**Licence Number** L8469/2010/2

**Licence Holder** Galaxy Lithium Australia Limited

**Premises**  
Mt Cattlin Project  
RAVENSTHORPE WA 6346  
Lot 31 on Plan 224145 and Lot 127 on Plan 145763  
(part of Mining tenement M74/244) Newdegate-  
Ravensthorpe Road RAVENSTHORPE WA 6346

**Date of Amendment** 25 January 2019

## Schedule 2 – Tailing storage facility general arrangements October 2018

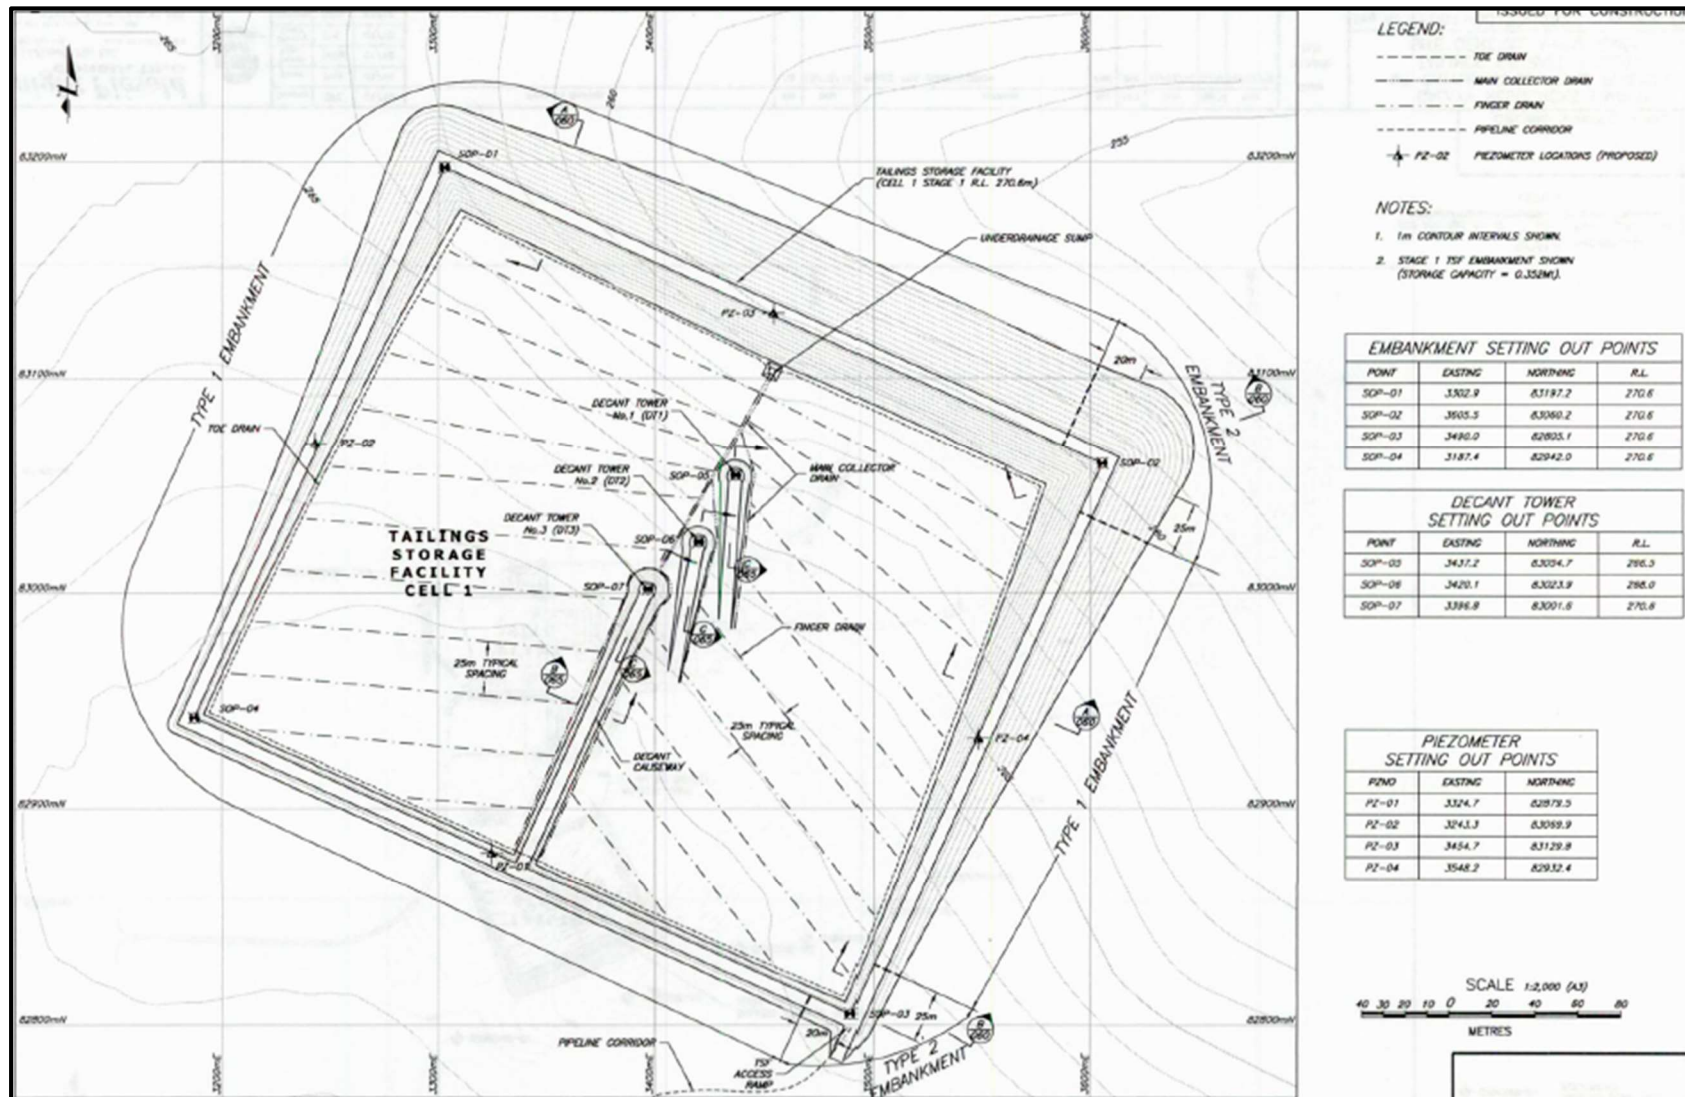
1.2.17 The License Holder shall complete construction of TSF cell 1 wall lift 3 in accordance with the documentation listed in Table 1.2.16 and as depicted in Schedule 2 titled "Tailing storage facility general arrangements October 2018".

The location of wall lift 3 is upon the existing wall of TSF cell 1.

## Schedule 2 – Embankment sections and details October 2018

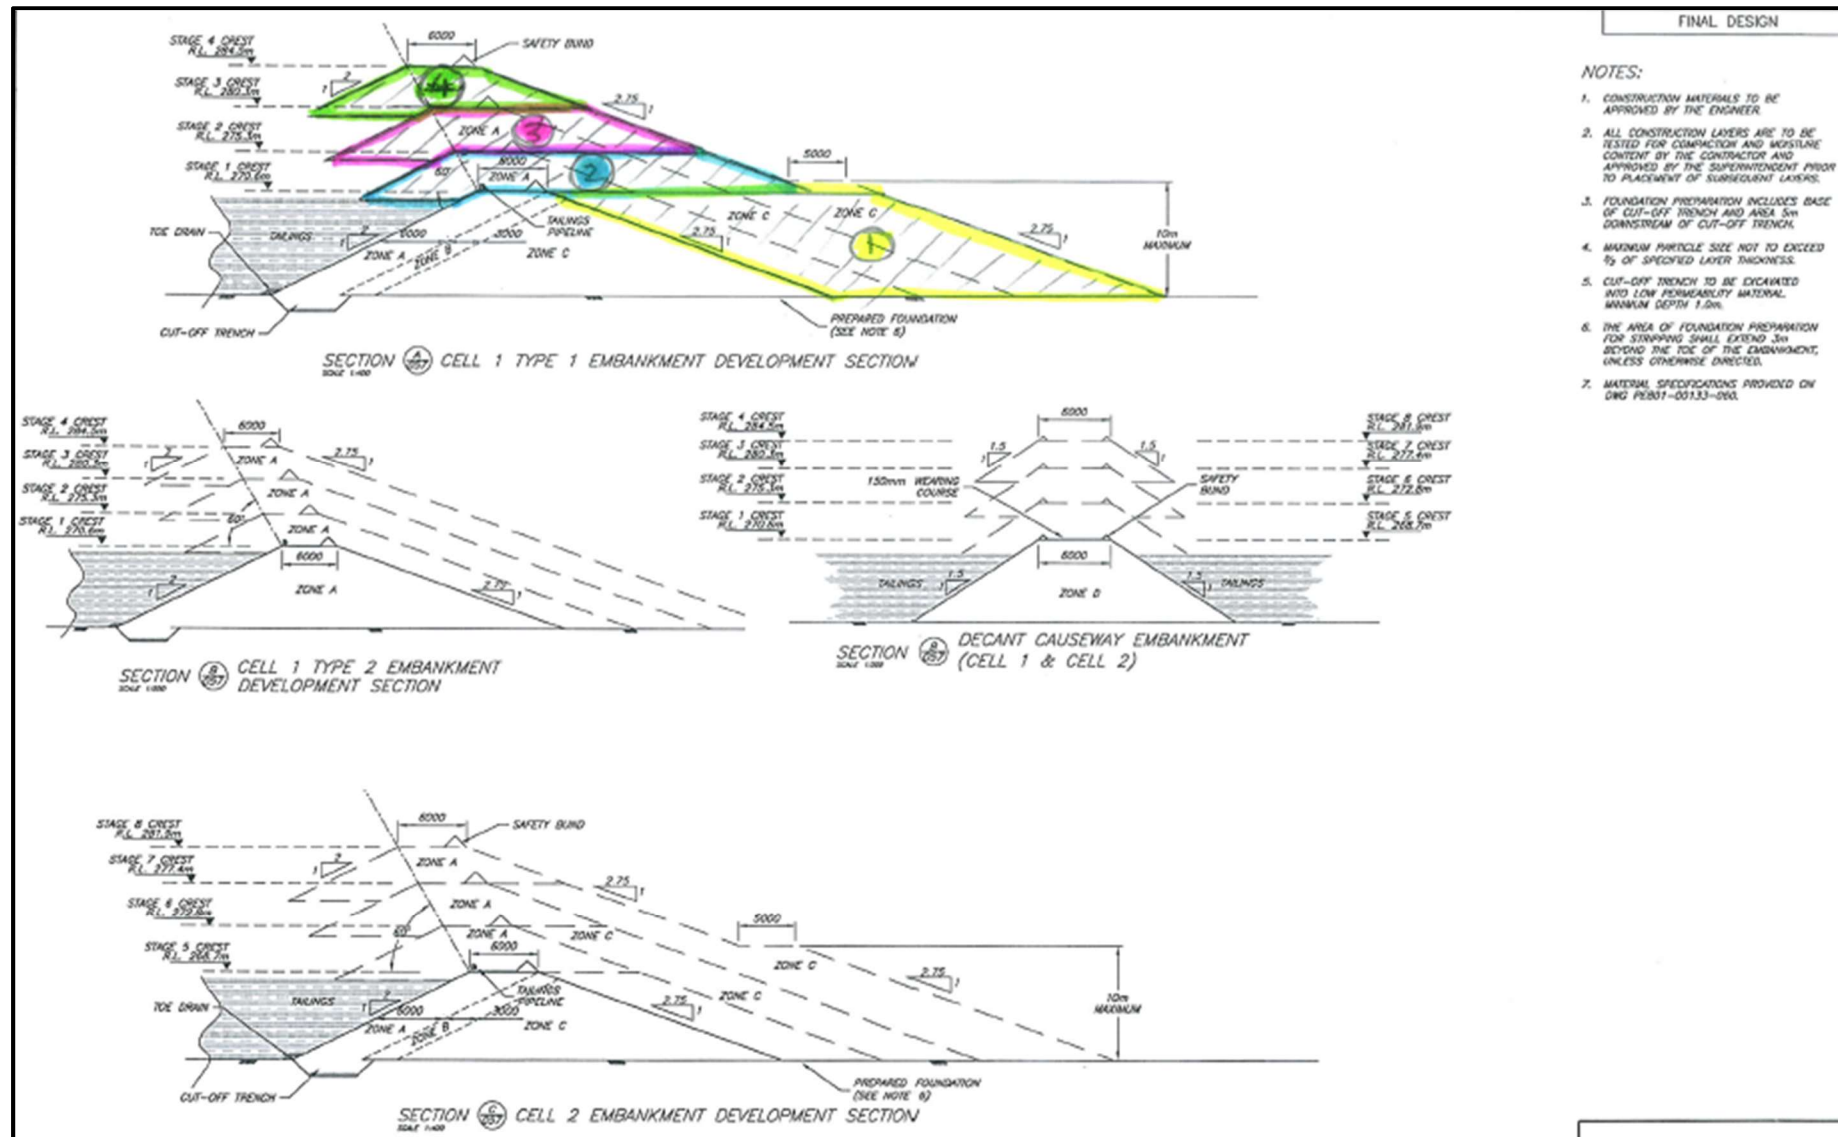
1.2.16 The License Holder shall construct TSF cell 1 wall lift 3 as indicated by purple colour numbered 3 in Schedule 2 title "Embankment Sections and Detail October 2018" to finish at a stage crest height of 280.3m RL.
